Preferred Project Report & Response to Submissions

Cabarita Mixed Use Proposal MP 07_0179

Prepared for WA Stockwell P/L

Preferred Project Report – Section 75H of the EP&A Act, 1979 Mixed Use Development at Cabarita Breach/Bogangar - MP 07_0179

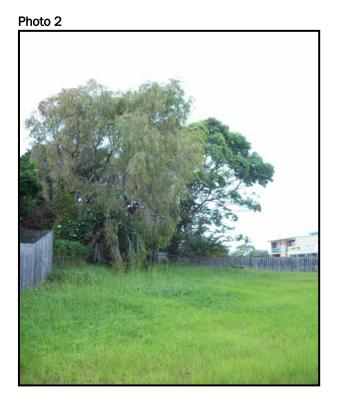
Photo 2 - The rear of Lot 2 in DP 772172. This critical section of the 3mtr laneway has not been constructed nor dedicated to Council. It is not until an application is lodged for the redevelopment of Lot 2 in DP 772172 that the Council can condition the applicant to provide this section of the laneway.

As shown on Plan No. DA-13G the 3mtr wide laneway has been provided in accordance with LEP 2000.

Study Area

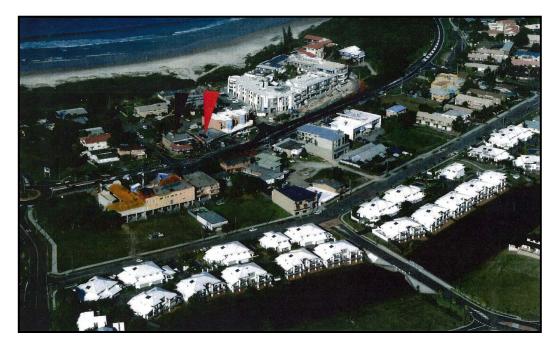
An objection was raised to the aerial photo contained in the EA. The subject photo showed a vacant land where the Reef Villa Development is constructed. Accordingly, an updated aerial photo is attached for reference.
